Wiring deltas easYgen-3100/3200/P1/P2 versus easYgen-3100XT/3200

Clemens - 2026-11-12 - easYgen-3000XT

AC Voltage Sensing inputs:

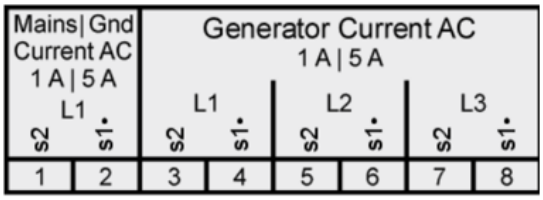
In old easYgen-3000 there are separate terminals for 120VAC and for 480VAC voltage sensing.

In easYgen-3000XT there is only a wide range voltage sensing input covering 120-480 VAC.

AC current sensing:

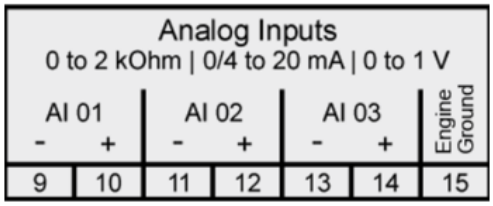
Old easYgen-3000 line had part numbers for ../1A or ../5A.

easYgen-3000XT can be used for ../1A or ../5A current sensing

Analog Inputs:

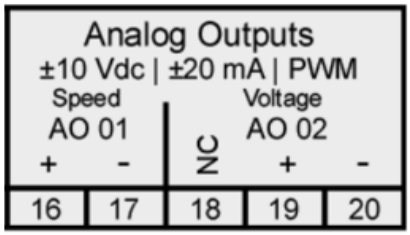
In old easYgen-3000 resistive senders up to 500Ohm and 0/4-20mA were supported. In 3000XT resistive inputs were increased to 2000Ohm and 0-1VDC senders are possible as well.

Communication Interfaces:

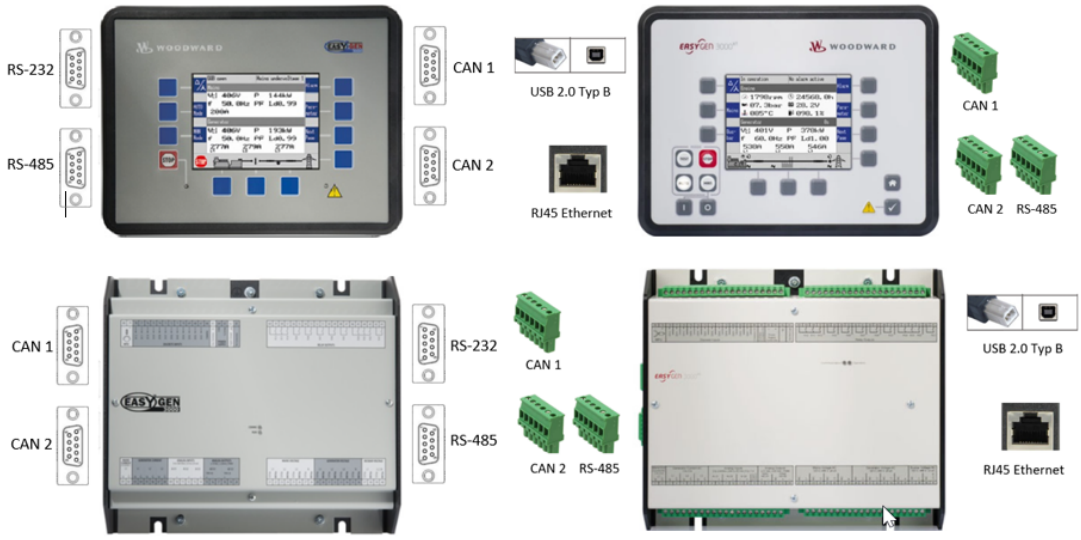
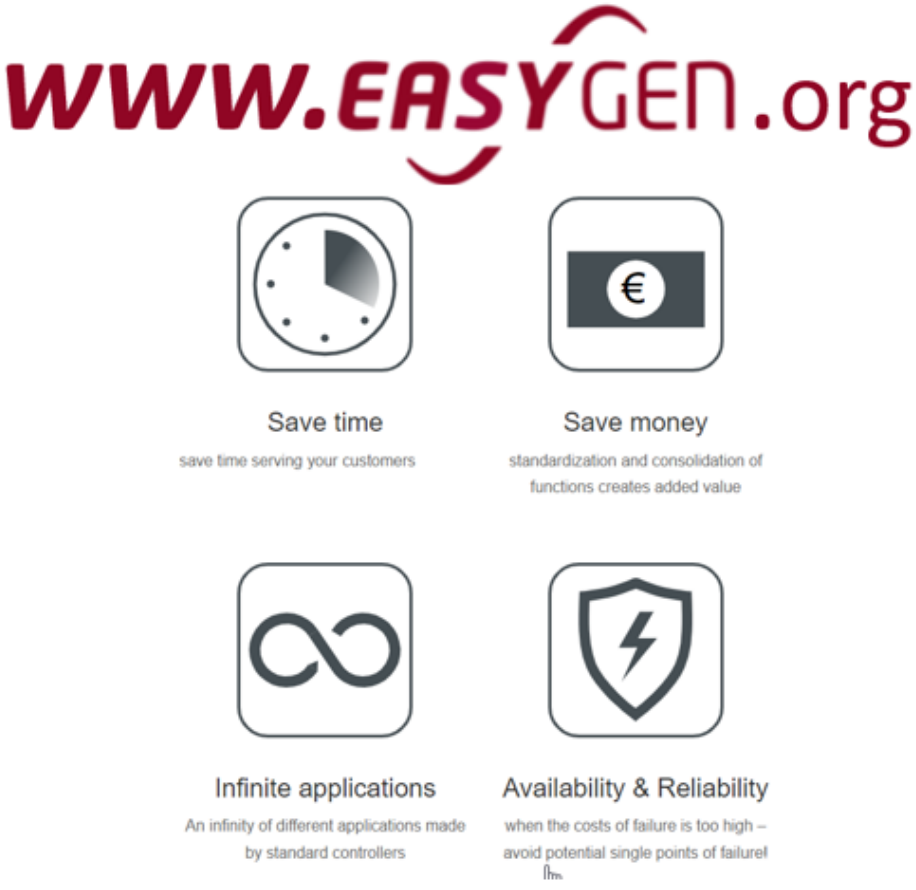
Old easYgen-3000 had D-sub sockets. RS232 port is used for Toolkit configuration. In easYgen-3000XT RS232 port was replaced by a USB 2.0 service port socket. In easYgen-3000XT D-sub sockets are replaced by terminals
